MEMORANDUM

TO: Knoxville-Knox County Planning Commission
FROM: Jessie Hillman, AICP | Principal Planner
DATE: August 8, 2023
SUBJECT: **8-A-23-HPA** Agenda Item #6
Level II Certificate of Appropriateness for 11 additional acres of disturbance in the Hillside Protection Overlay at 0 Central Avenue Pike, Parcel ID 068 075
Article 8.9: HP Hillside Protection Overlay Zoning District
Article 16.8.A.4 & B.4: Overlay Districts – Certificates of Appropriateness, Purpose and Applicability & Process for the HP Overlay Zoning District

8-A-23-HPA

Exhibit B: Original Slope Analysis for entire parcel

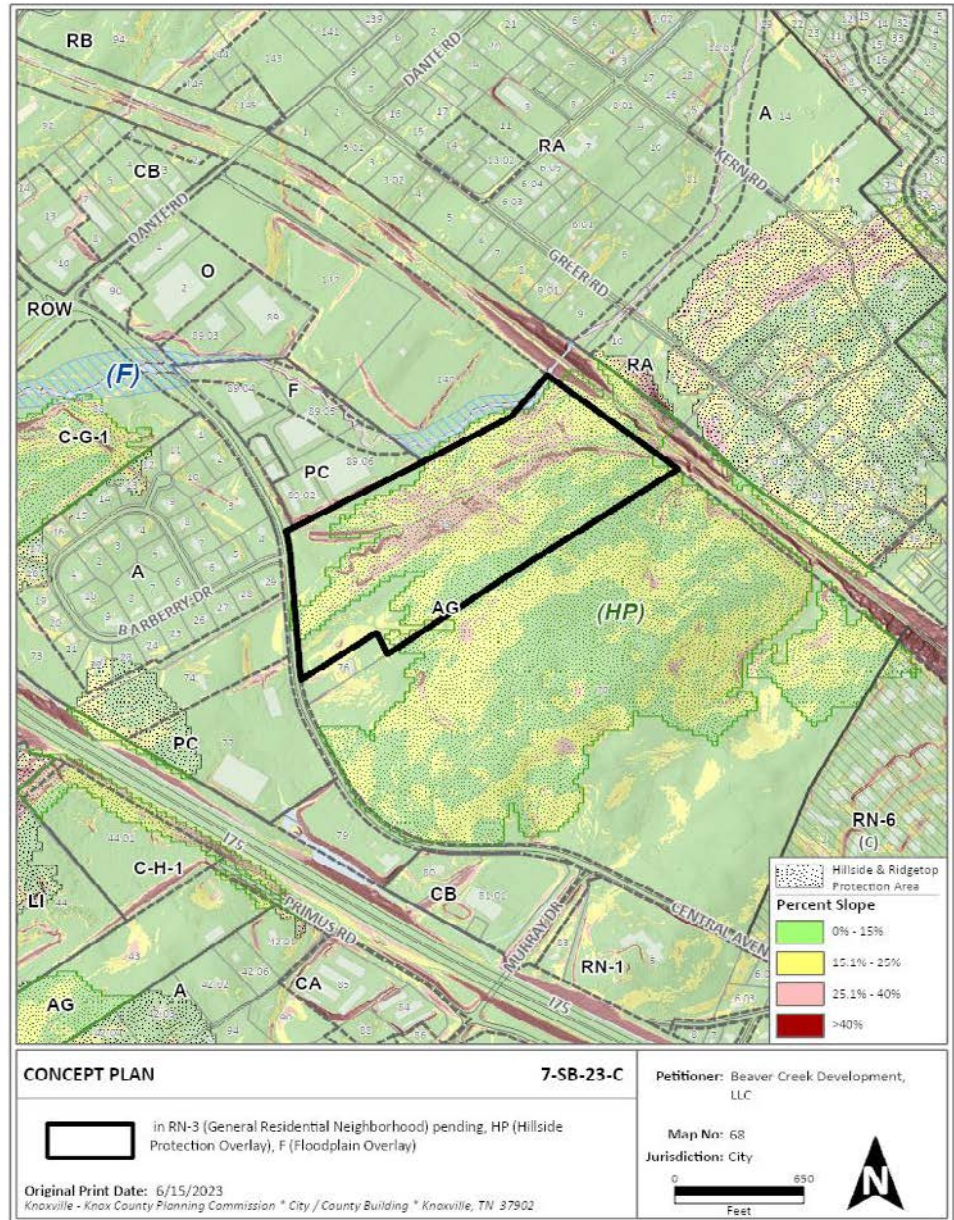
Approximately 14 acres of the parcel have been previously cleared and are unbuildable due to a TVA utility easement. The original slope analysis conducted for the entire parcel as part of the concept plan review provides a disturbance budget of no more than 14.17 acres within the HP Overlay, as shown in Exhibit B. Since the TVA easement is equivalent in area to the disturbance budget, this limitation is a significant impediment to potential development of the site.

This interpretation is not consistent with that of Planning staff or the City Plans Review and Inspections Department (PR&I), as reflected in the attached letter from PR&I (Exhibit D). The previously legally disturbed area within an HP Overlay is considered as part of the maximum land disturbance budget, not separate from it.

Exhibit C: Alternative Slope Analysis for buildable area

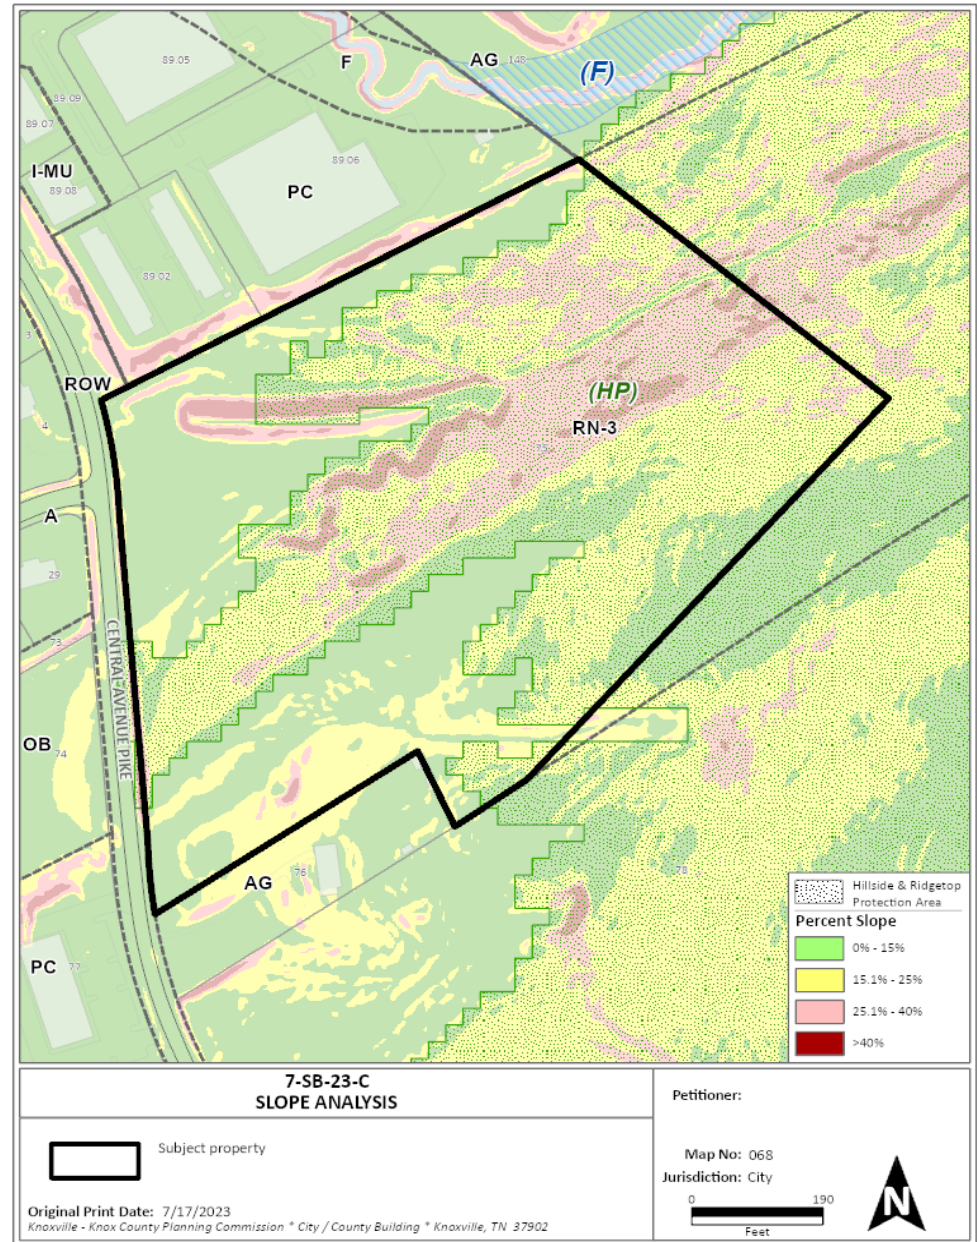
Planning Staff conducted an alternative slope analysis, shown in Exhibit C, which excludes the undevelopable TVA easement, and provides a disturbance budget of 5.23 acres within the HP Overlay of the remaining property. This alternative disturbance calculation is consistent with the intent of the Hillside Protection Plan, which acknowledges in its preface that, "flexibility will be needed in applying these general goals and principles to specific proposals and site conditions on unique parcels of land, and leaves room for approval of sound engineering and creative solutions to meet these objectives." Approving a COA based on a disturbance limit of 5.23 acres rather than the 11 acres requested balances the integrity of the HP Overlay District with practical development considerations.

Approve the applicant's Level II Certificate of Appropriateness (COA) request to develop within the HP (Hillside Protection) Overlay zoning district, on the condition that disturbance within the HP Overlay not exceed 5.23 acres outside of the Tennessee Valley Authority (TVA) utility easement on the site.
